North Addition to Grandview Commons Phase 10
Addendum No. 1
Contract: 9094, Project: 13854

Approval RES-23-00079, File # 75066, 2/10/23

Addendum No. 1

Addendum No 1 showing the pavement patch on Saturn Drive.

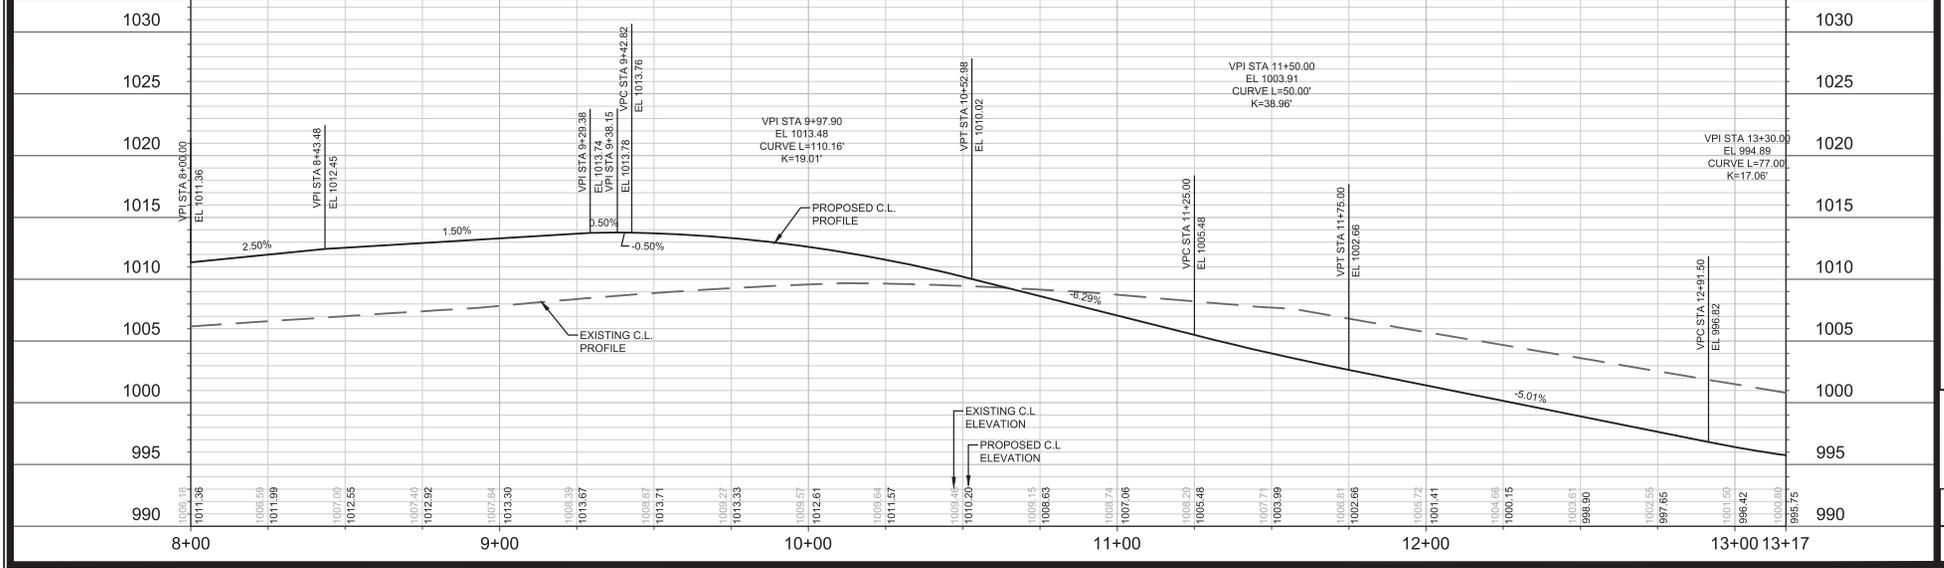
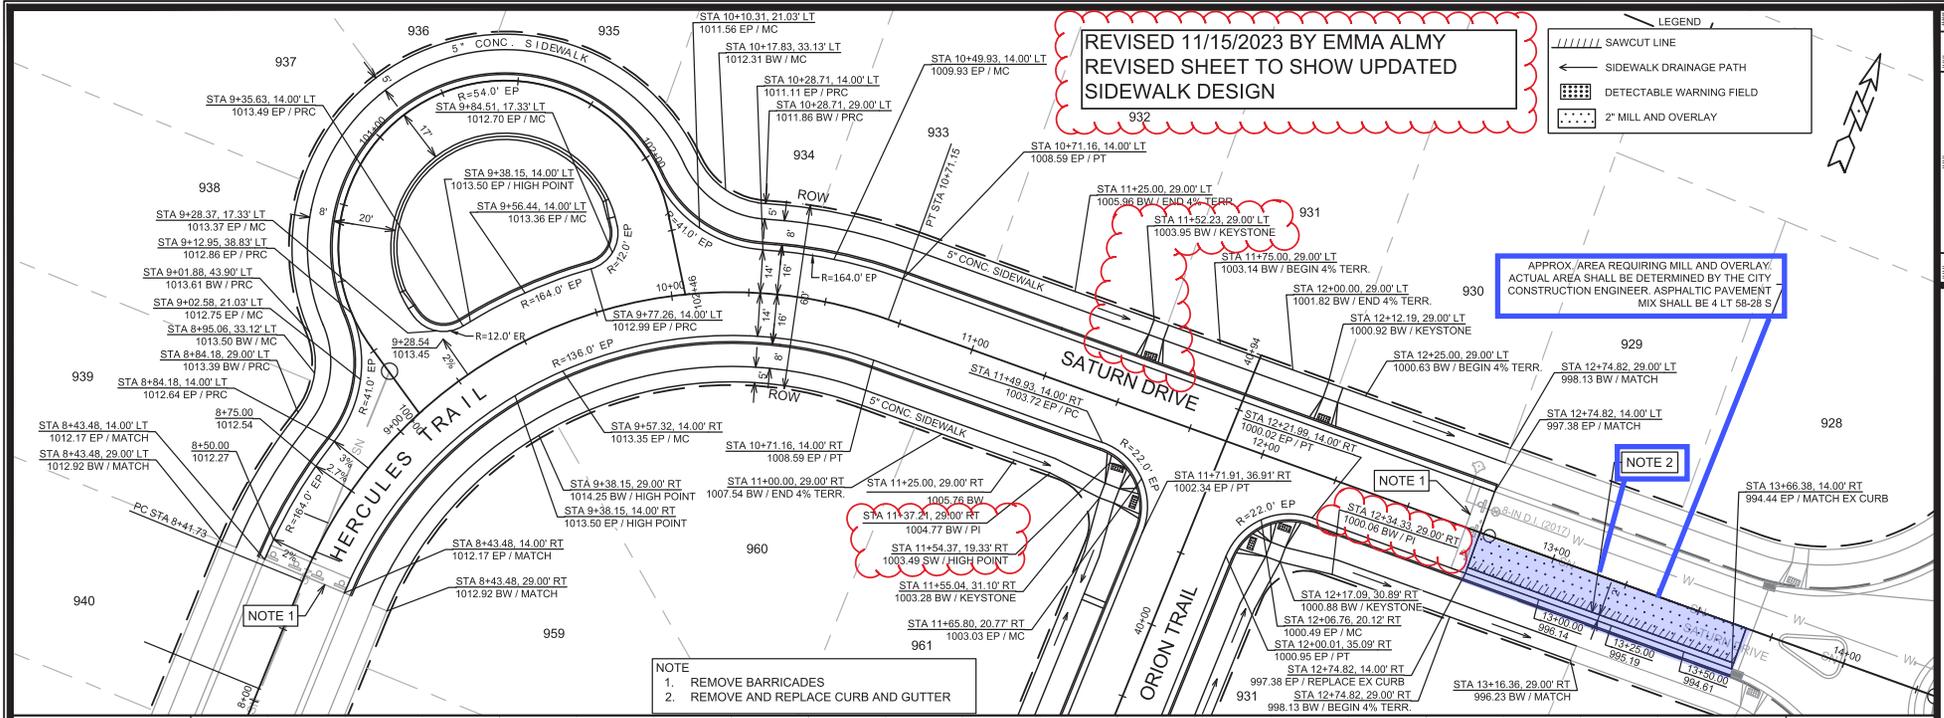
Developer to connect new public storm sewer to existing storm sewer outside of project limits at the intersection of Milky Way and Saturn Drive. The new storm sewer connection for Phase 10 could be installed under the curb line, which would require the removal/replacement of curb/gutter and asphalt restoration work or in the terrace without disturbing the existing street.

The determination is to install the storm sewer in the typical location under the curb and gutter. This option also allows for the planting of two additional terrace trees that would otherwise not be allowed with storm sewer in the terrace.

- Remove and replace existing curb and gutter, approximately 100 LF.
- Repair asphalt paving per City of Madison Pavement Patching Criteria to centerline of Saturn Drive.
- Install new 12" storm sewer pipe.
- The City shall reimburse the developer up to \$12,000 for the cost of the curb and gutter removal and asphalt pavement repair.
